UNITED STATES ENVIRONMENTAL PROTECTION AGENCY

**SUBJECT:** Concurrence Request for Approval of Alternative Model: BLP/AERMOD Hybrid Approach for Modeling Buoyant Roofline Sources at the FMMI Copper Smelter in Miami, AZ

## **EPA Region IX Technical Review of Arizona Department of Environmental Quality's Request to Use BLP/AERMOD Hybrid Approach**

**Figure 3.** Ambient Monitor Locations Relative to the Miami Smelter. Attainment TSD, Appendix C, Figure 3.

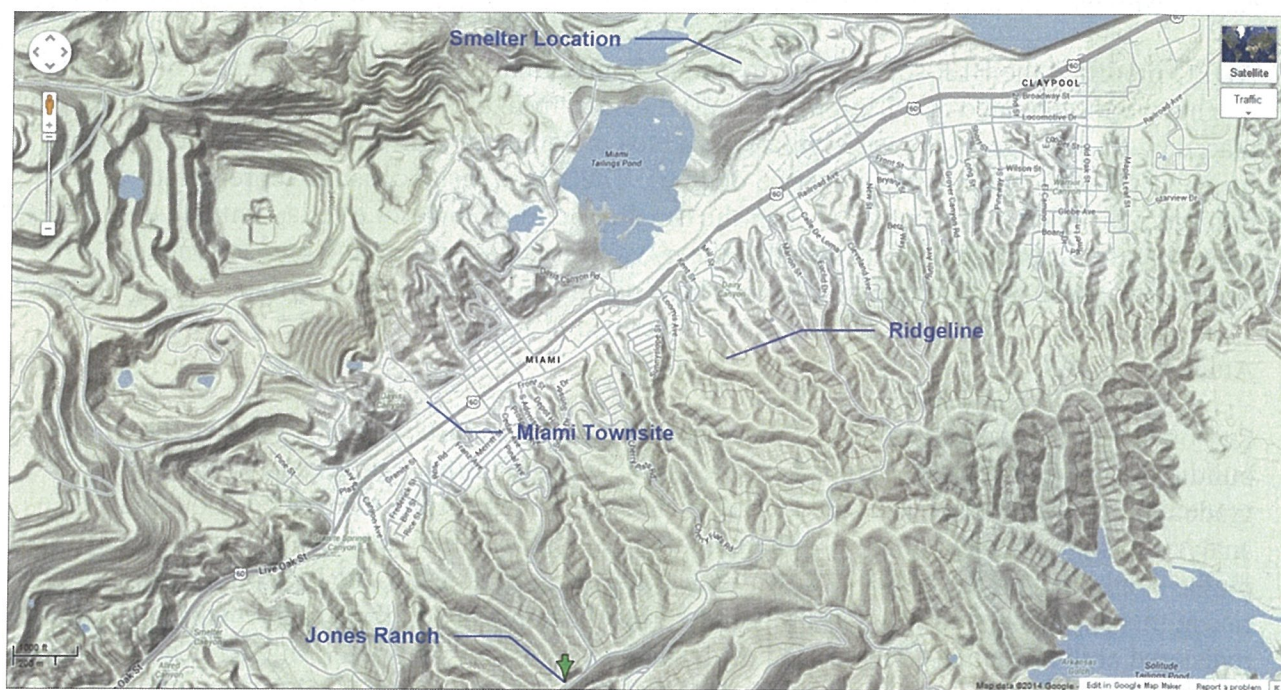
Region IX staff were concerned that placing volume sources instantaneously above the smelter building would not accurately represent the initial location of the sources and would neglect gradual plume rise and downwash. During plan development, ADEQ provided additional analysis to support this modeling approach, including information concerning the choice of final plume height and  $\sigma_z$ , the effect of downwash and near field impacts, the lack of gradual plume rise in this approach, and whether proposed controls adequately address high concentrations registered at the Miami Townsite monitor located in the valley below the smelter. The additional analysis and discussion can be found in the Attainment TSD, Section 5.2.3.2, Appendices D and L, and are summarized below.

ADEQ performed a number of sensitivity analyses to justify using final plume height at 1 km and  $\sigma_z$  at 250 m. *See* Attainment TSD, Appendix D. The analysis showed that a 1 km receptor distance represents final plume height and that  $\sigma_z$  does not change markedly with this distance from the smelter, suggesting excessive dilution would not be an issue. *See* Attainment TSD, Appendix D, Table 1A-1B and 3A-3B. The topography of the region and existing monitoring suggest that elevated 1-hour concentrations are expected to impact adjacent topography where final plume rise has been achieved, therefore, gradual plume rise would not affect predicted

concentrations (Figure 3). Additionally, the approach adequately captures observations at existing monitors at elevation as described in Section 4 below.

The Miami Townsite SO<sub>2</sub> monitor, however, is located in the valley below the smelter and is not affected by buoyant roofline emissions. See Figure 3 and Attainment TSD, Figure 5-6. To examine the effect of downwash on receptors near the smelter boundary, ADEQ ran BLP with and without downwash. Concentrations at receptors near the smelter did not change, suggesting if there are any ground level impacts due to downwash they fall within the facility boundary (i.e., the ambient air boundary) or do not occur at all. ADEQ found that high concentrations at the Miami Townsite monitor are due to morning inversion breakup fumigation conditions not represented in AERMOD or BLP. ADEQ used AERSCREEN in fumigation mode to assess contributions at those locations. See Attainment TSD, Appendix L. The analysis shows that stack sources are the major contributor to the elevated concentrations (whereas the roof vents are not) and that emission reductions from the Smelter Upgrade Project are sufficient to provide for attainment in these low-lying areas.

**Figure 4.** Q-Q Plots for Jones Ranch (top) and Ridgeline (bottom) monitors, Modeling TSD, Appendix C, Figure 4.

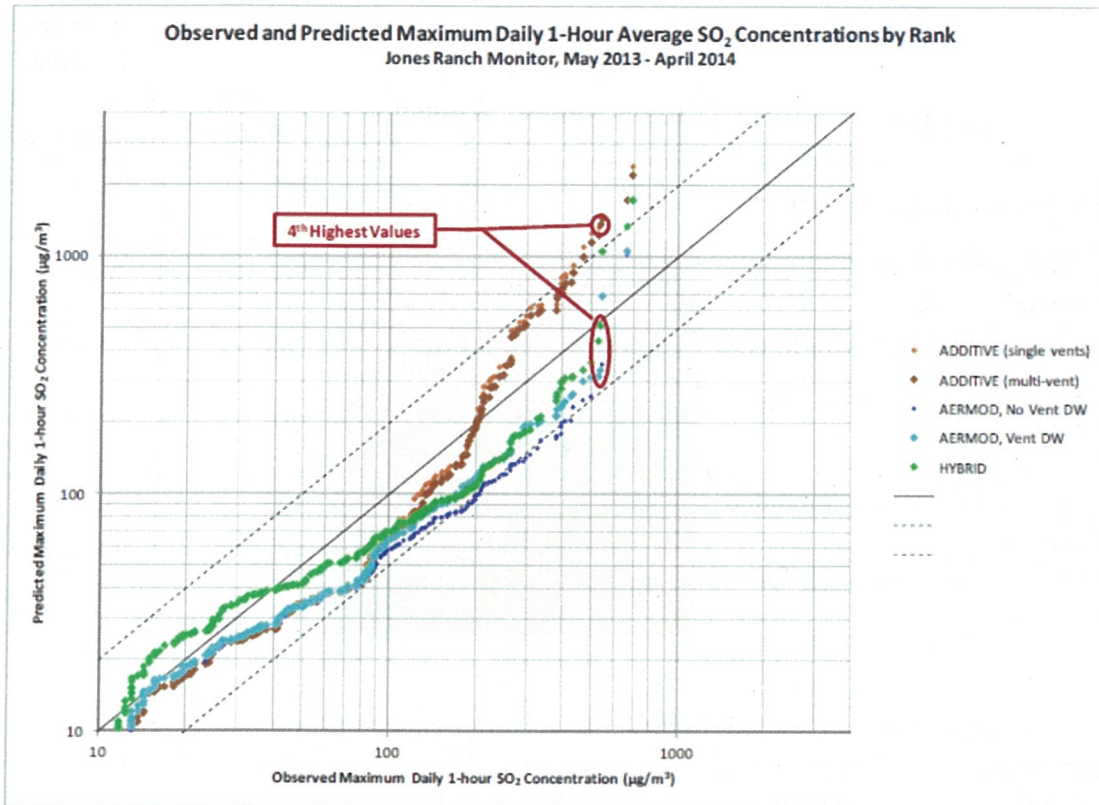
Table 2 and the Figure 4 show that the alternative model approach (BLP/AERMOD Hybrid) most closely predicts measurements at the Jones Ranch location, which is the site most indicative of roofline sources, and is within a factor of two at the Ridgeline location. In contrast, the preferred model (Additive BLP/AERMOD) approach substantially over-predicts at both locations, suggesting the BLP/AERMOD Hybrid approach performs better than the preferred model for roofline buoyant sources for this particular application and topography. In the Performance Memo, ADEQ provided an additional statistical analysis following the methodology outlined in the Protocol for Determining the Best Performing Model. First, the State conducted a screening test followed by a composite performance measure (CPM), which includes both operational and scientific evaluations of model performance.
